SUBJECT: DIABLO CANYON POWER PLANT, UNIT NOS. 1 AND 2 - STAFF
ASSESSMENT OF INFORMATION PROVIDED UNDER TITLE 10 OF THE
CODE OF FEDERAL REGULATIONS PART 50, SECTION 50.54(f), SEISMIC
HAZARD REEVALUATIONS FOR RECOMMENDATION 2.1 OF THE
NEAR-TERM TASK FORCE REVIEW OF INSIGHTS FROM THE FUKUSHIMA
DAI-ICHI ACCIDENT (CAC NOS. MF5275 AND MF5276)

STAFF ASSESSMENT BY THE OFFICE OF NUCLEAR REACTOR REGULATION

RELATED TO SEISMIC HAZARD AND SCREENING REPORT

DIABLO CANYON POWER PLANT UNIT NOS. 1 AND 2

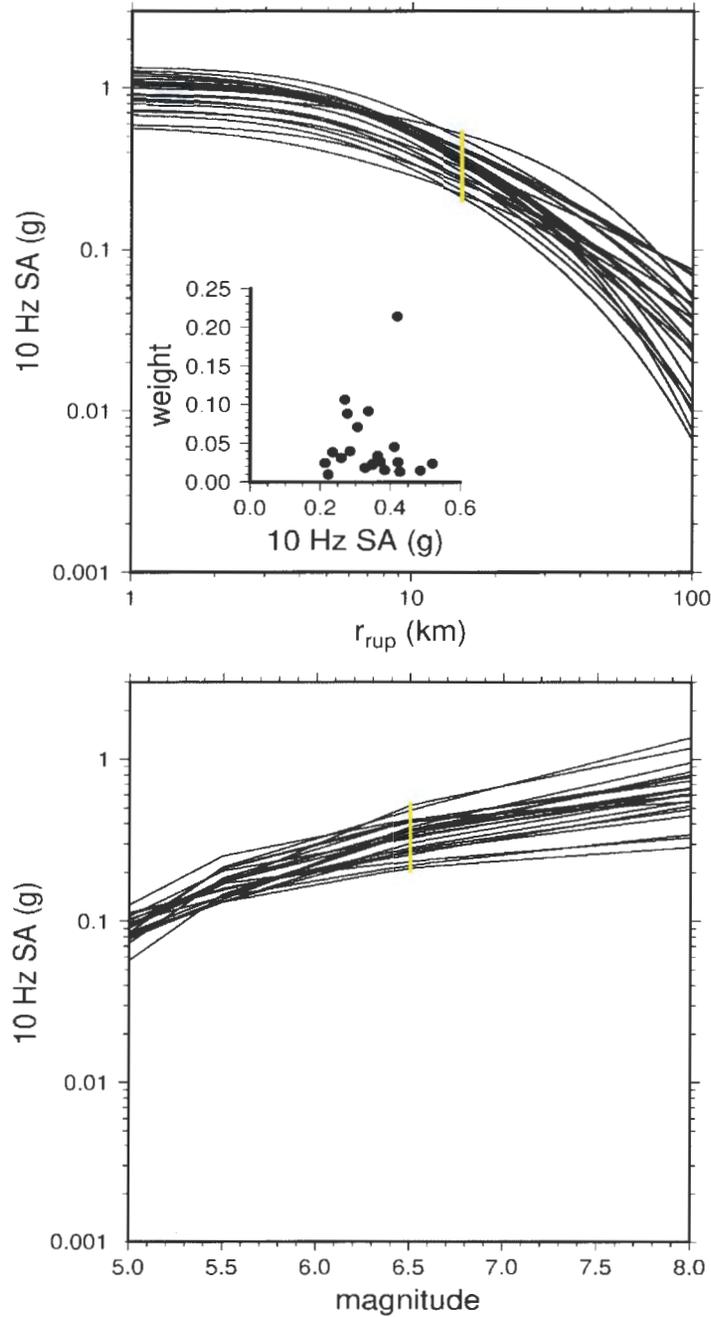
To evaluate the distribution of median GMPEs produced by the TI Team for the local sources, the NRC staff examined the behavior of the models for multiple earthquake magnitude and source-to-site distance combinations. Figure 3.2-1(a-b) of this staff assessment shows the distribution of weighted medians produced by the set of GMPEs using the Sammon's map approach for the local sources. Specifically, Figure 3.2-1(a) shows the distribution of weighted median results from the 22 GMPEs developed for a spectral period of 0.1 s for a **M6.5** earthquake for source-to-site distances ranging from 1 km to 100 km. Similarly, Figure 3.2-1(b) shows the same GMPEs for a source-to-site distance of 15 km for earthquake magnitudes ranging from **M5** to **M9**. Shown in the inset to Figure 3.2-1(a) is the weighted distribution of median spectral accelerations for a **M6.5** earthquake at a source-to-site distance of 15 km. As shown by the inset to Figure 3.2-1(a), the 22 predicted weighted medians are centered at a reasonable value (0.4g) and cover a suitably wide range of spectral accelerations (0.2g to 0.6g). In addition, Figures 3.2-1(a) and (b) show that the 22 median GMPEs have alternative magnitude and distance scaling approaches, as demonstrated by the intersecting models.

Figure 3.2-2. Low, central, and high values for the three components of aleatory variability [τ (red), ϕ_{ss} (blue), σ_{ss} (black)] as a function of magnitude. Solid lines represent the median variability and dashed lines represent the upper and lower bounds.

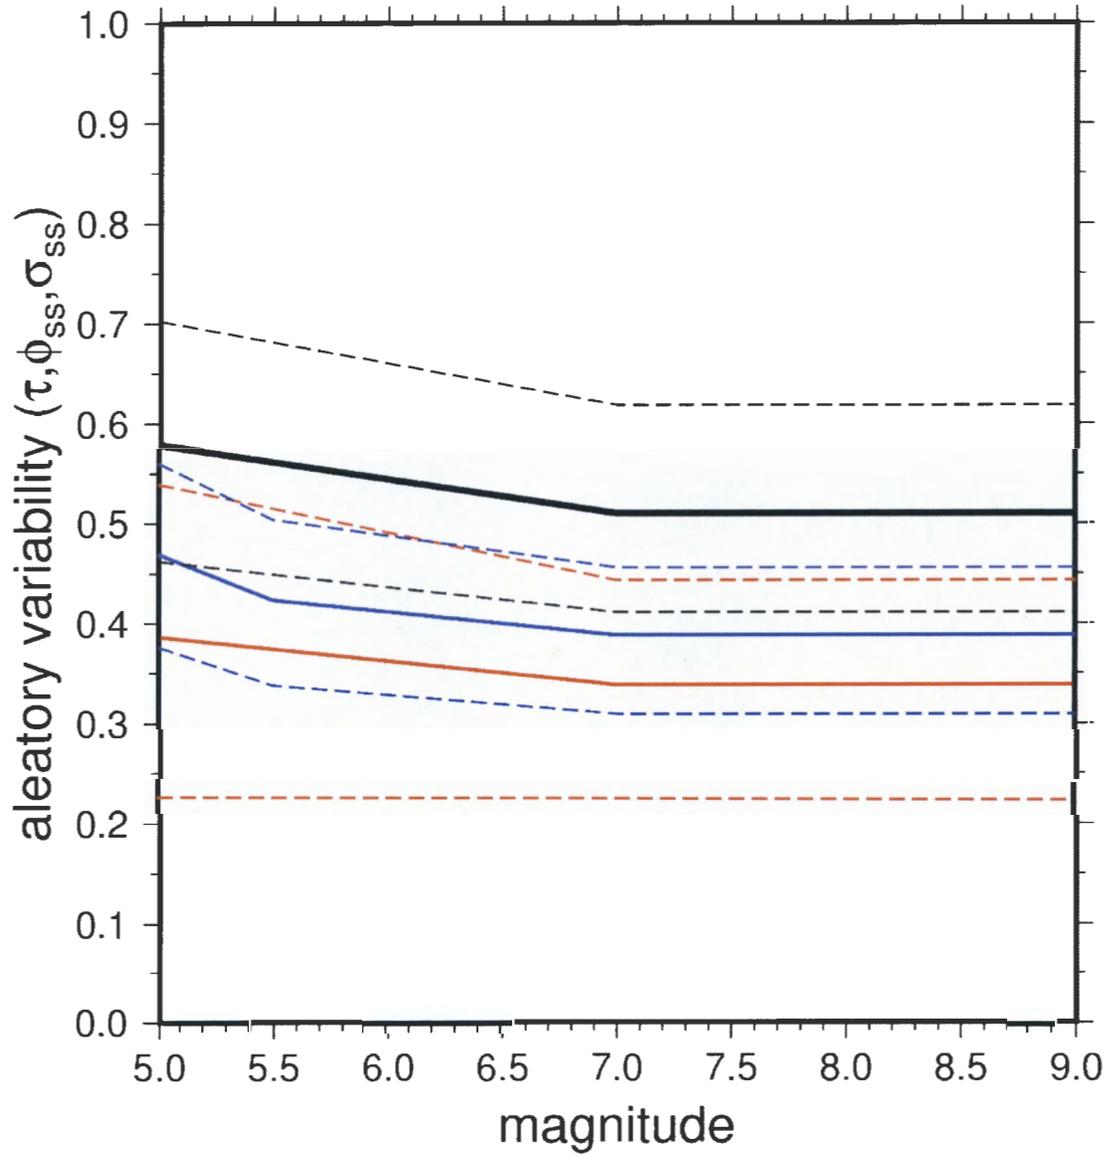
To evaluate the ground motion variability about the predicted median spectral accelerations, the NRC staff compared the values predicted by the TI Team's τ and ϕ_{SS} models with estimates calculated from other GMPEs. Based on these comparisons, the staff concludes that the TI Team's τ and ϕ_{SS} models, as well as the resulting single-station sigma model, produce reasonable estimates of the ground motion variability for each of the earthquake scenarios considered for the DCPP PSHA. Figure 3.2-2, which displays the low, central, and high values for the three components of aleatory variability (τ , ϕ_{SS} , σ_{SS}) as a function of magnitude, shows

Figure 3.3-1. Four local faults (black lines) and virtual faults (yellow lines) used in the NRC staff's confirmatory analyses.

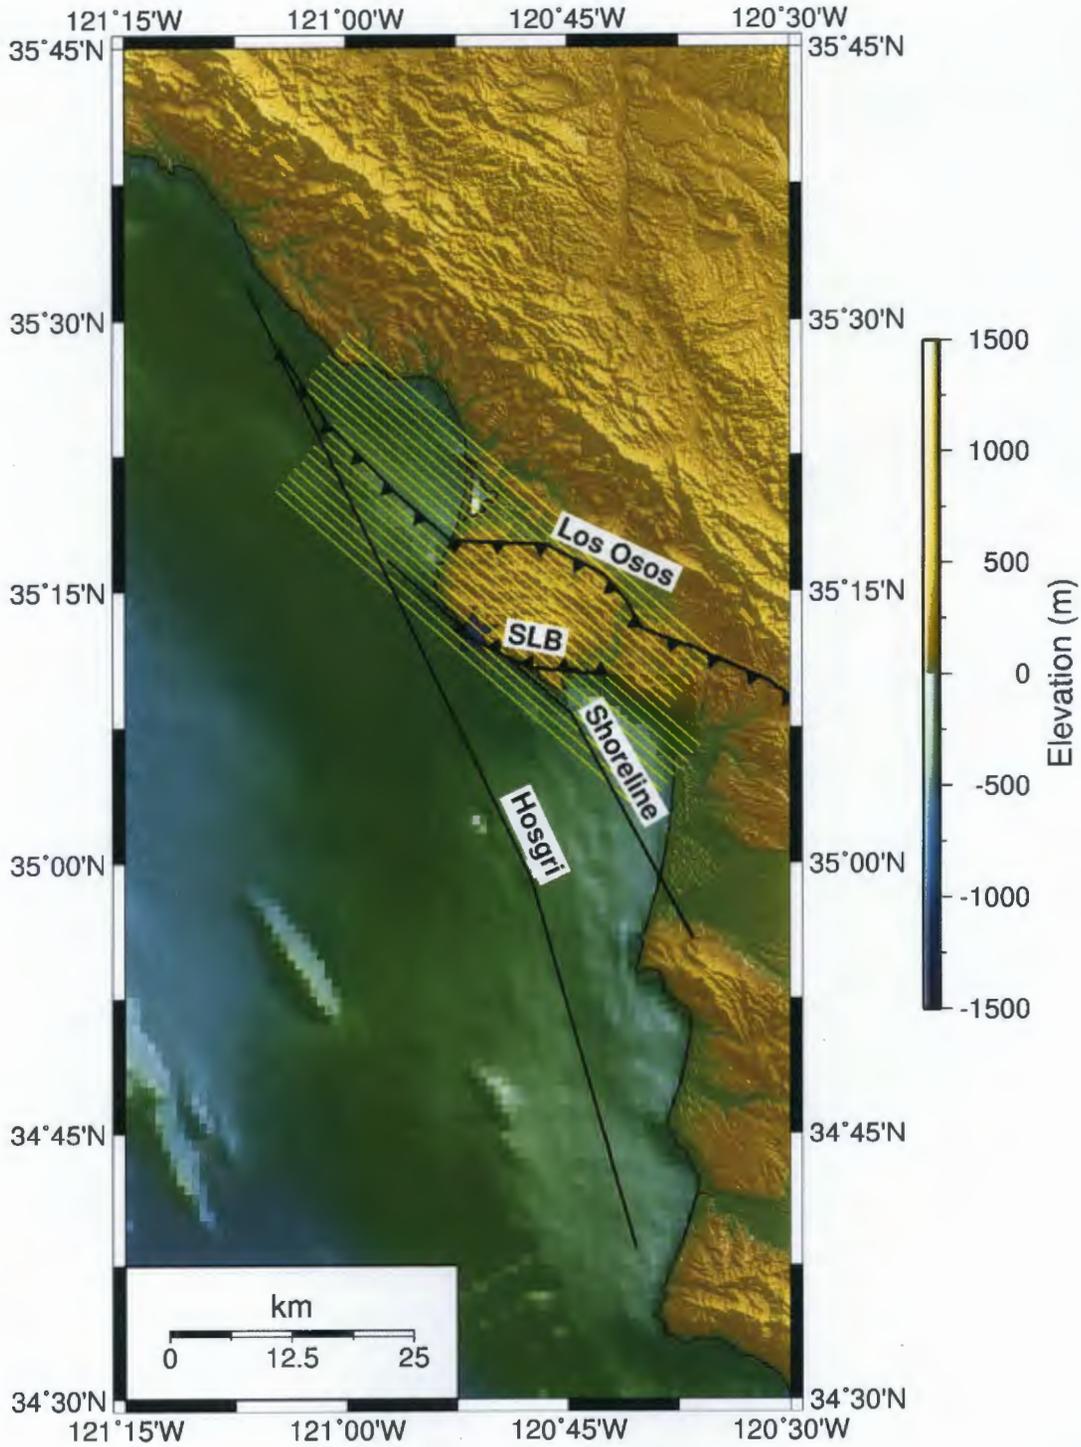
The local fault sources selected by the NRC staff for its confirmatory evaluation are the Hosgri, Shoreline, Los Osos, and San Luis Bay faults (see Figure 3.3-1 of this staff assessment). For each of the fault sources, the staff primarily focused on either the Hosgri or the Outward Vergent Fault geometry model and modeled a range of earthquake ruptures on these primary faults using the characteristic earthquake distribution (Youngs and Coppersmith, 1985). Rather than

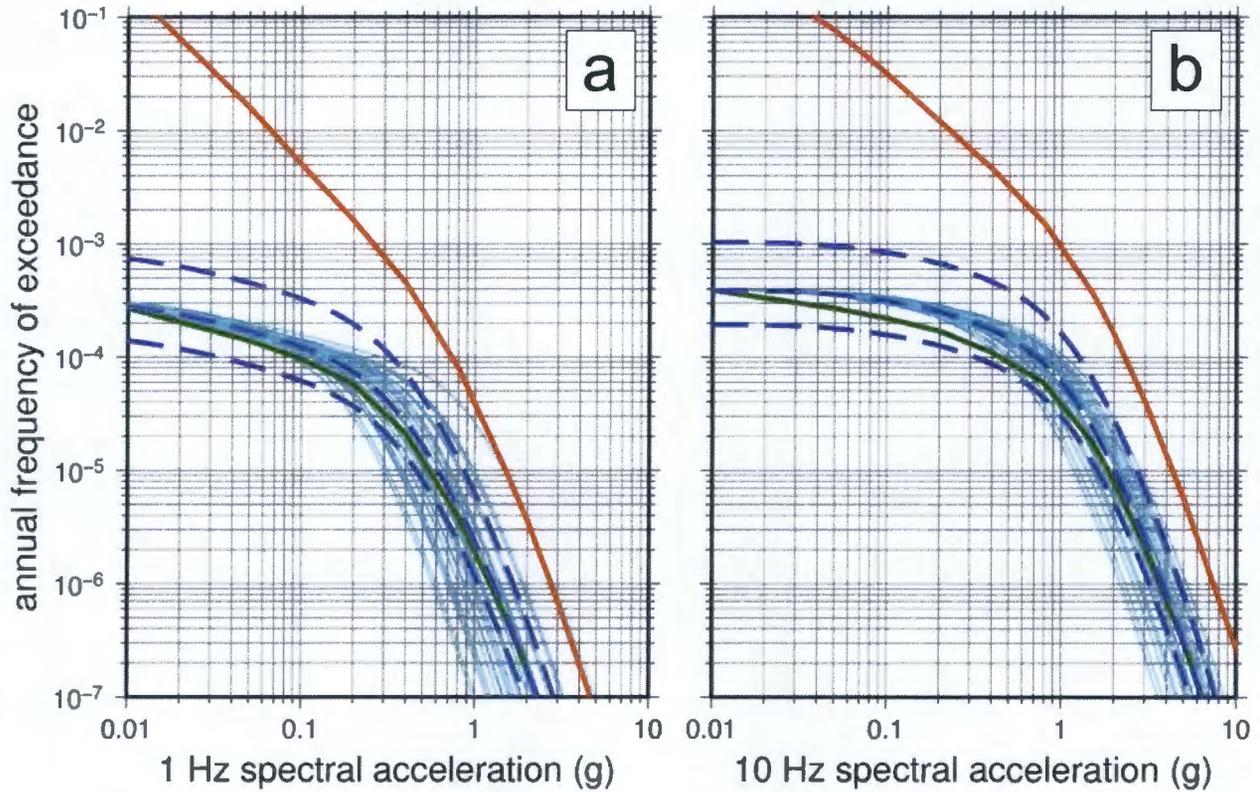
Figures 3.3-3(a-b) of this staff assessment show the NRC staff's 1 and 10 Hz hazard curves for the Shoreline fault assuming the OV-01 fault geometry model, a maximum magnitude of 6.7, a fault length of 51 km, a width of 12 km, and fault slip rates of 0.03, 0.06, and 0.16 mm/yr. As shown in Figures 3.3-3(a-b), the NRC staff's confirmatory results encompass the licensee's hazard results for both the 1 Hz and 10 Hz mean hazard curves. Similarly, for the Los Osos and San Luis Bay faults, the staff used the OV-07 and OV-05 Outward Vergent rupture models along with the 5th, 50th, and 95th percentile fault slip rates to develop 1 Hz and 10 Hz hazard curves. The staff's confirmatory results for these faults are similar to the licensee's results at the 10⁻⁴ and 10⁻⁵ annual frequencies of exceedance even though the SSC TI Team allocated only a portion of the total fault slip rates to these two rupture models. Additionally, the staff notes that these confirmatory calculations, similar to the licensee's calculations, show that the seismic hazard at the DCPD is controlled by the Hosgri fault.

Figure 3.4-5. Licensee's sensitivity analysis of the Uniform Hazard Spectra to the site term approach, from PG&E (2015d).

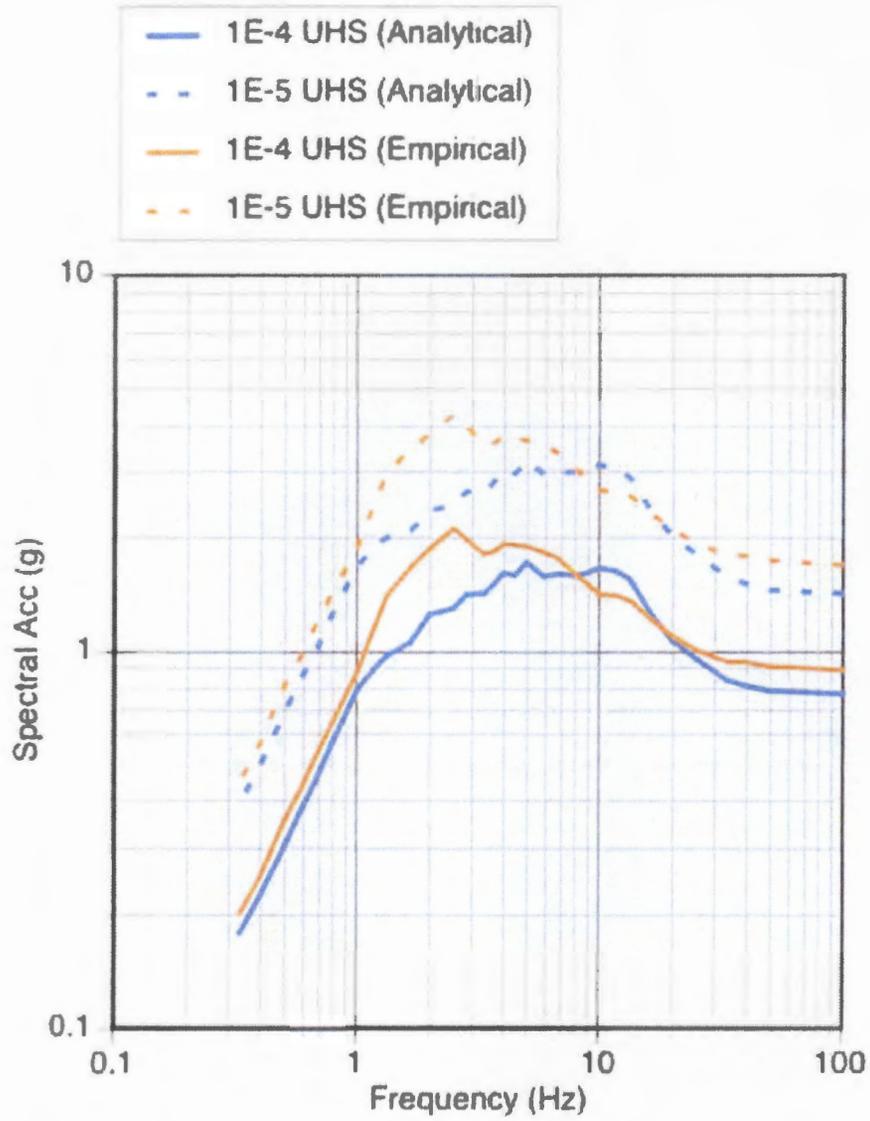
Figure 3.4-5 from the licensee's revised SHSR (PG&E, 2015d) shows the 10^{-4} and 10^{-5} annual exceedance frequency uniform hazard response spectra (UHS) from the empirical and analytical approaches. The main difference between the two UHS is the site resonance near 2 Hz that is captured by the empirical approach, but not by the analytical approach. The NRC staff notes that the licensee's decision to more heavily weight the empirical approach retains this 2 Hz amplification as part of the final GMRS for the DCPD.

Figure 3.5-1. Initial Ground Motion Response Spectrum (GMRS; black dashed line) and Double Design Earthquake (i.e., SSE; green dashed line) from SHSR for DCP (PG&E, 2015a). Revised GMRS (red solid line) from PG&E (2015d).

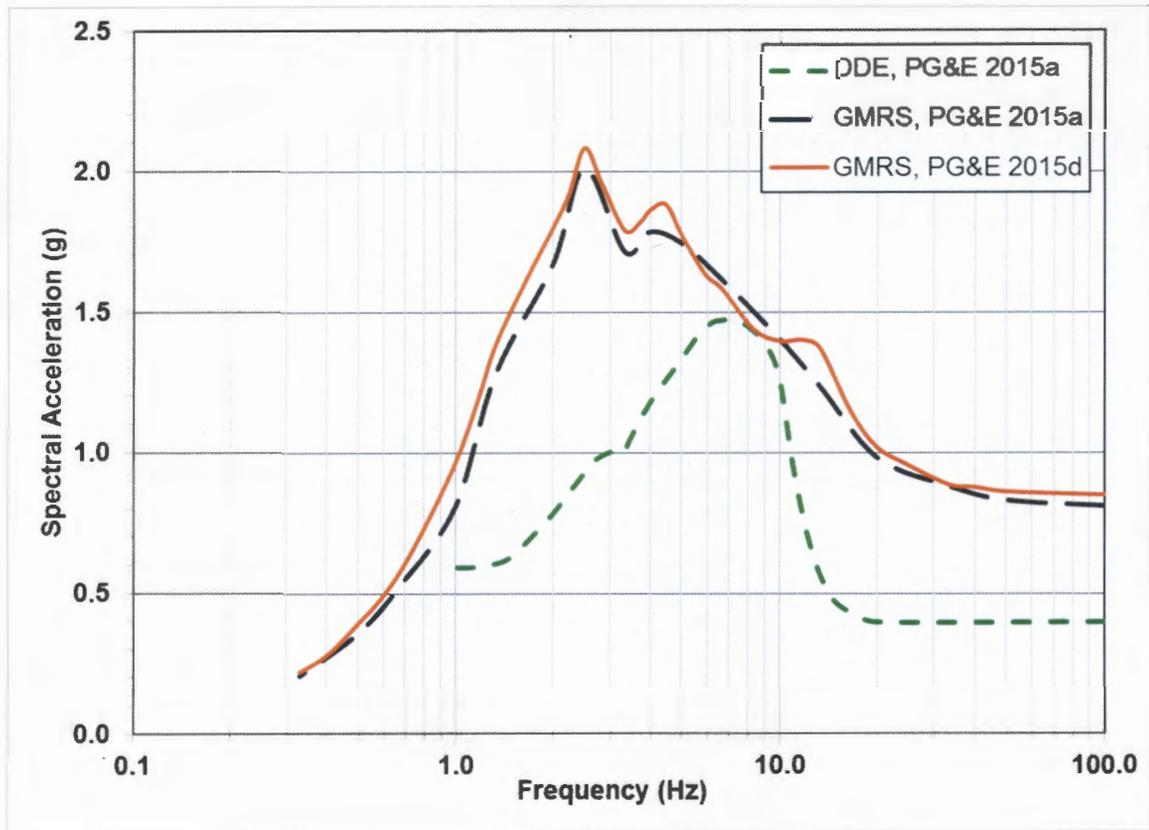
The GMRS is used to represent the free-field seismic hazard at the control point elevation. To calculate the GMRS, the licensee first used site-specific rock hazard curves from the PSHA (reviewed in Section 3.3 of this staff assessment) and the site term adjustment factors (reviewed in Section 3.4) to calculate control point hazard curves. The licensee then used these curves to develop 10^{-4} and 10^{-5} (mean annual frequency of exceedance) uniform hazard response spectra, and then computed the GMRS using the criteria in Regulatory Guide 1.208 (NRC, 2007). In response to RAIs, the licensee updated the GMRS initially submitted in PG&E (2015a) to incorporate additional information in the DCPD site response (PG&E, 2015d). The licensee's initial and updated horizontal GMRS for the DCPD site are shown in Figure 3.5-1 of this staff assessment.
